ADDENDUM NO. 01

Project: **2024 Jersey Village High School Renovation**
Cypress-Fairbanks Independent School District

Issued by: Texas Arcadis Inc.
P.O. Box 891209
Houston, Texas 77289
281-286-6605

Texas Arcadis Inc.
Project No.: 202319

AREA 'G1' 1ST FLOOR PLAN

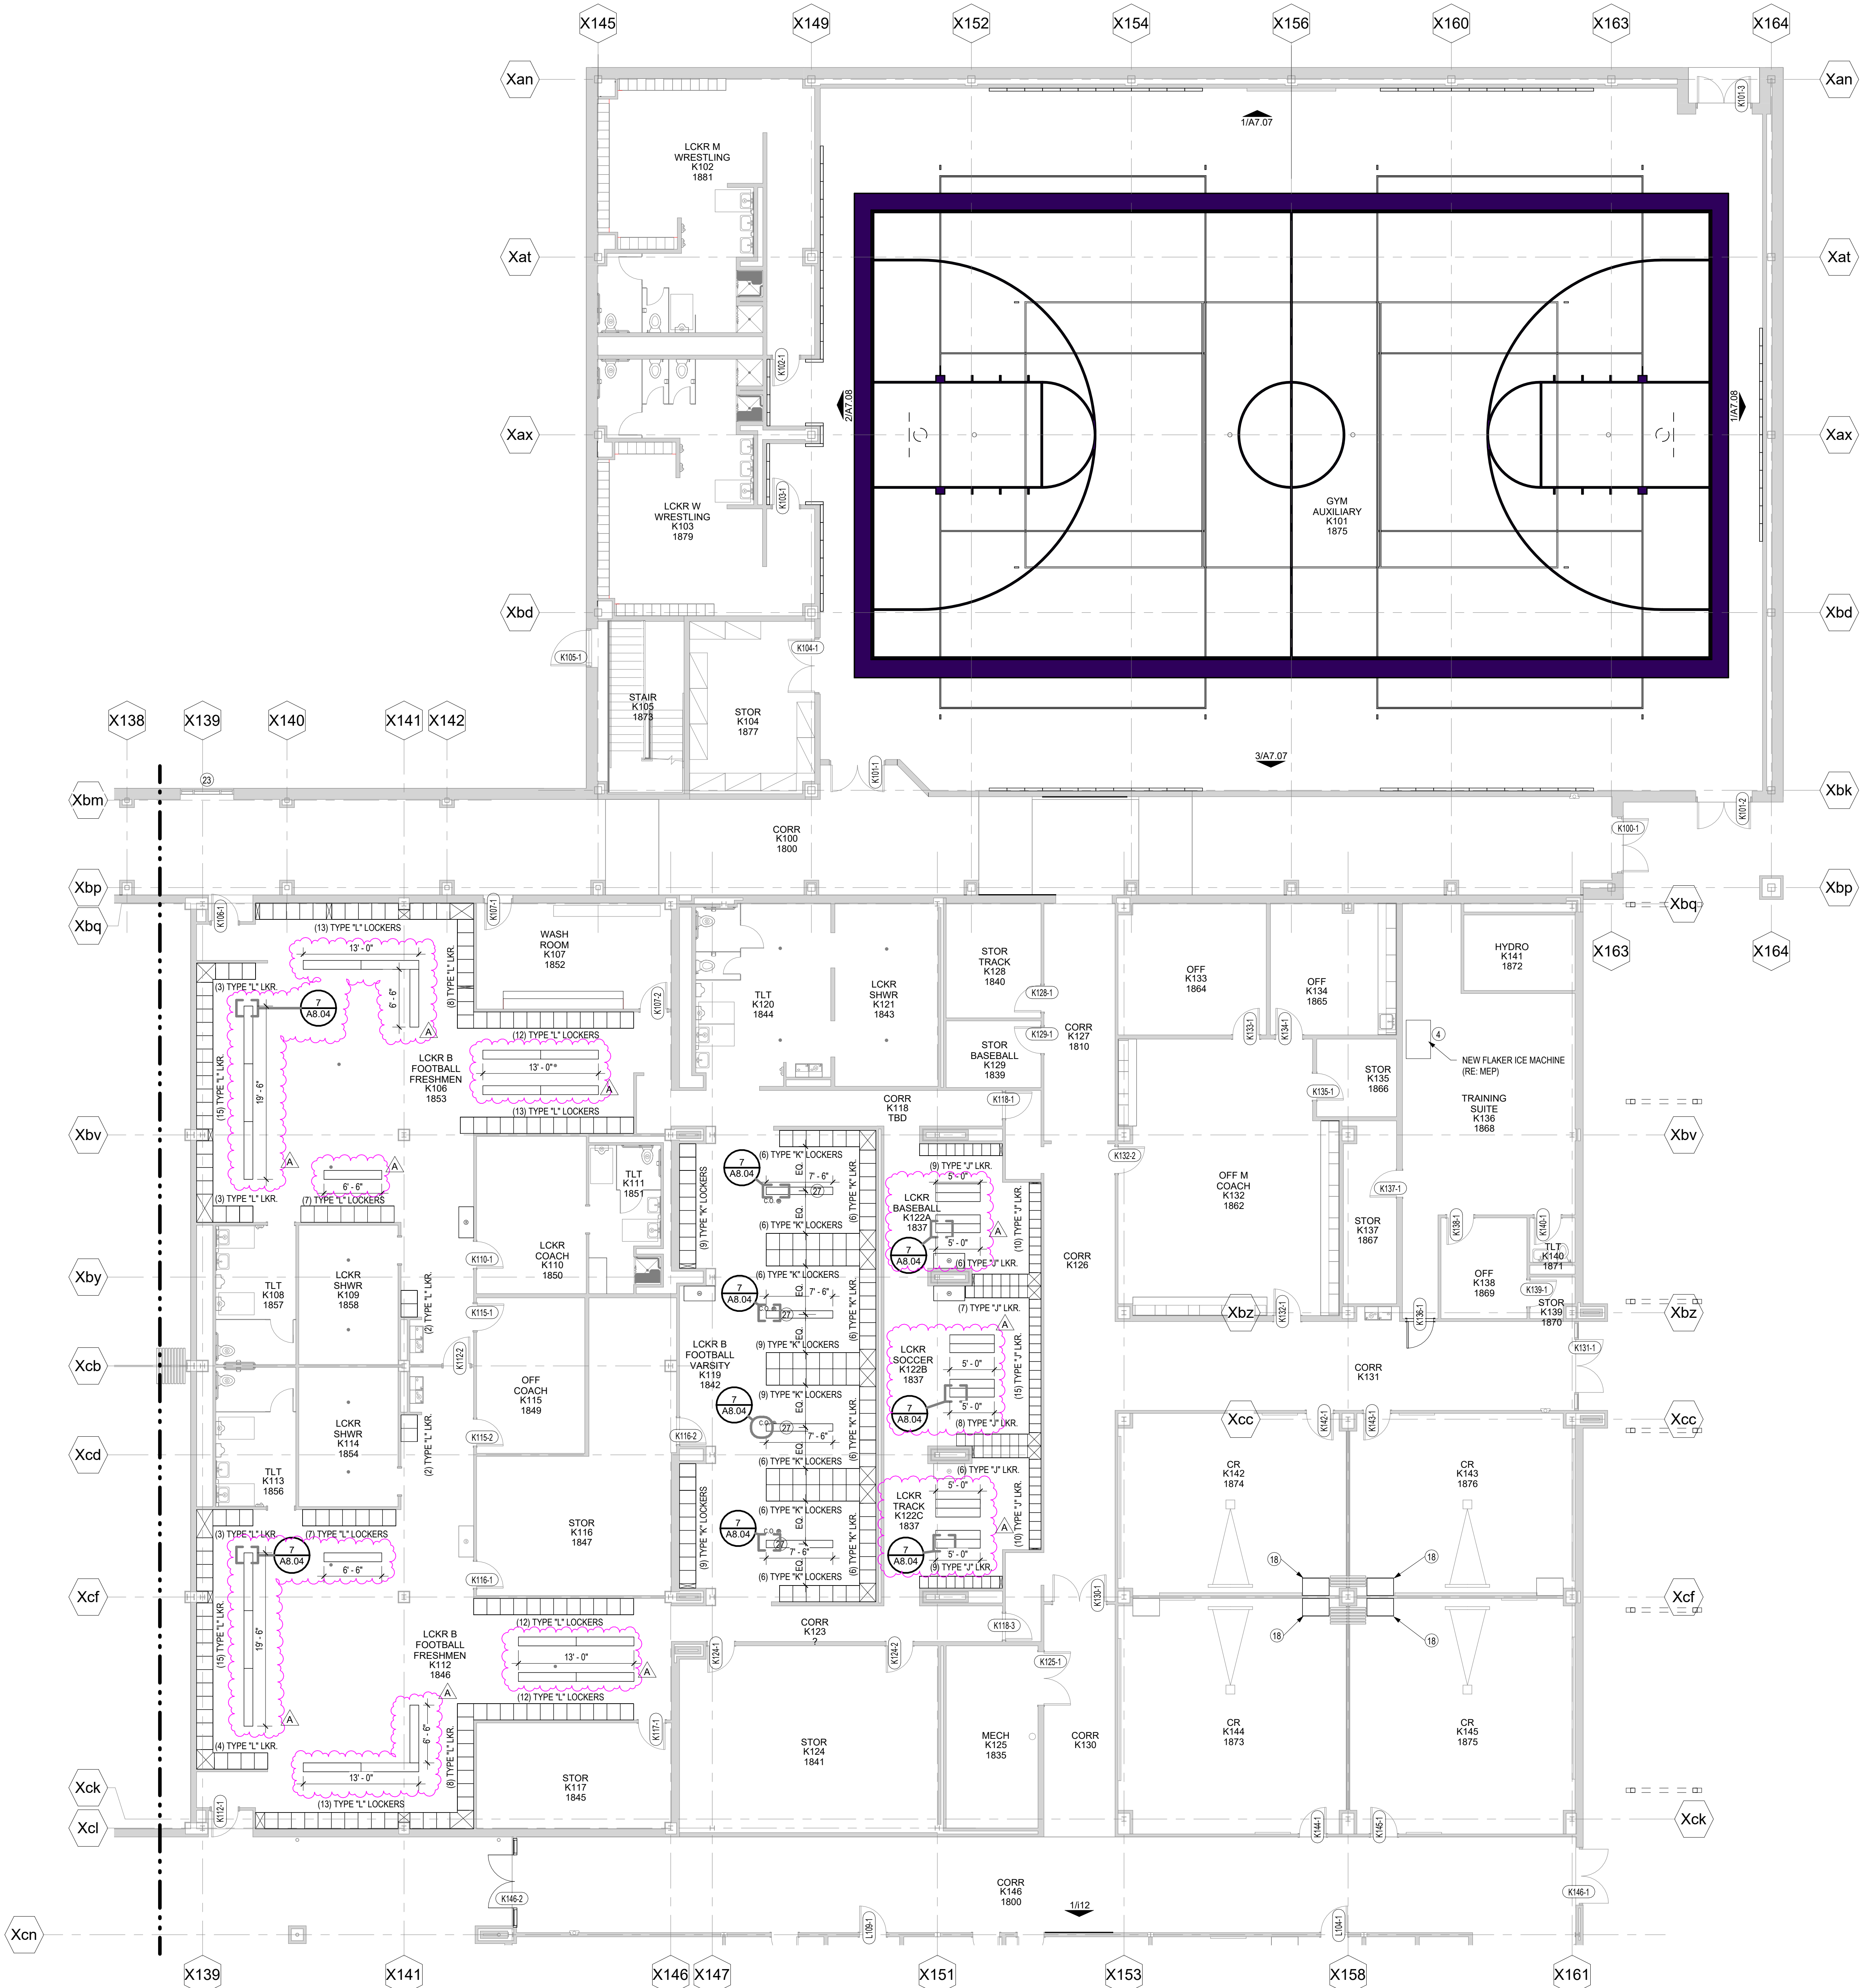
- a. Revise Casework and Window G102 “RECEPTION”
 - b. Revise Casework G116 “STOR COSTUME”, G118 “LCKR DRESS B”, G120 “STOR COSTUME”, G11 “CONTROL RM”, G121 “SHOP SCENE”

A2.10
 AREA 'K1' 1ST FLOOR PLAN

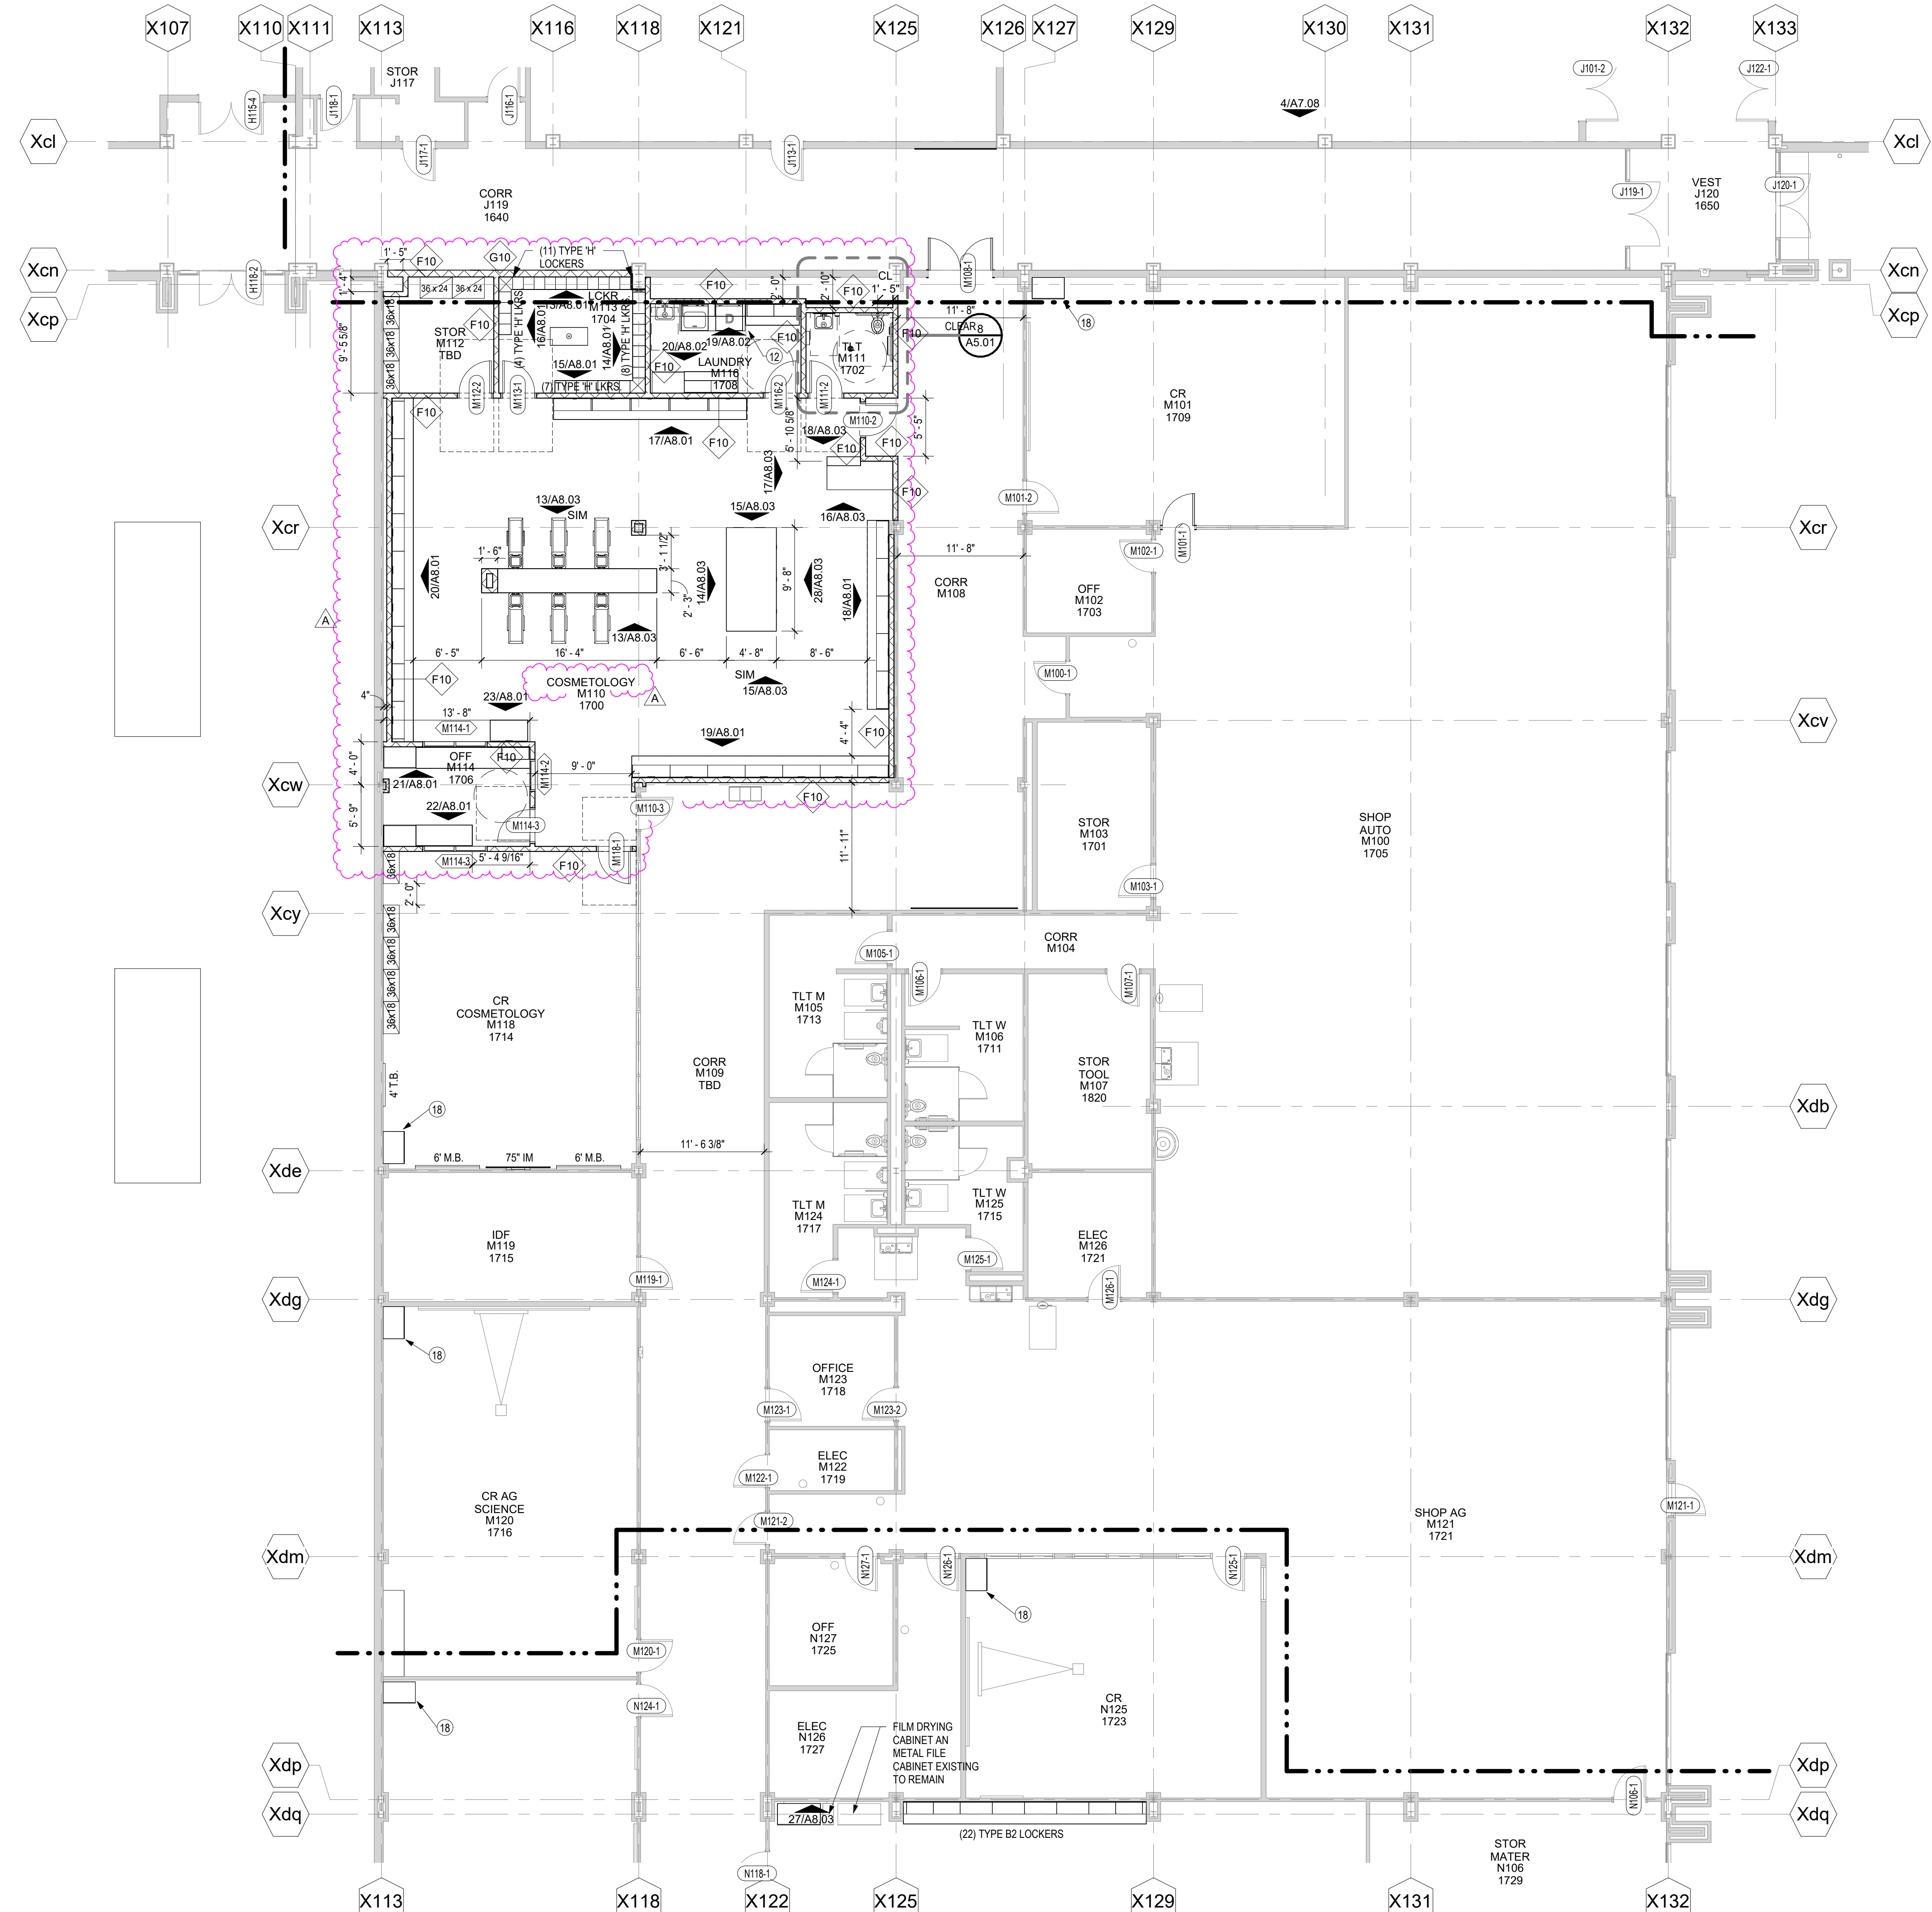
- 61. Sheet A2.10 – Area “K1” 1st Floor Plan
 - a. Add new locker room benches per reissued sheet, reference detail 7/A8.04. Add dimensions to new locker room benches.
- 62. Sheet A2.12 - Area “M1” 1st Floor Plan
 - a. Revise M100 “COSMETOLOGY”, M116 “LAUNDRY”, M112 “STOR”, M114 “OFF” casework.
- 63. Sheet A2.13 - Area “N1” 1st Floor Plan
 - a. Revise N118, N117, N109, N110, N115, N111, N112 “CR PHOTO” casework
 - b. Revise N121 and N122 “OFF” casework
- 48. Sheet A2.14 - Area “P1” 1st Floor Plan
 - a. Revise P104 “OFF KIT” casework
- 49. Sheet A2.16 – Area “R1” 1st Floor Plan
 - a. Revise R113 “EDITING” room casework
 - b. Revise R146 “FASHION LAB” casework
 - c. Revise R110 “CR ART”, R106 “CR SCULPTURE” caseworks
 - d. Revise R122 “ART STOR” caseworks
 - e. Revise R123 “ART WRK RM” caseworks
 - f. Revise R121 “ART DIGITAL” caseworks
 - g. Revise R124 “CR ART” caseworks
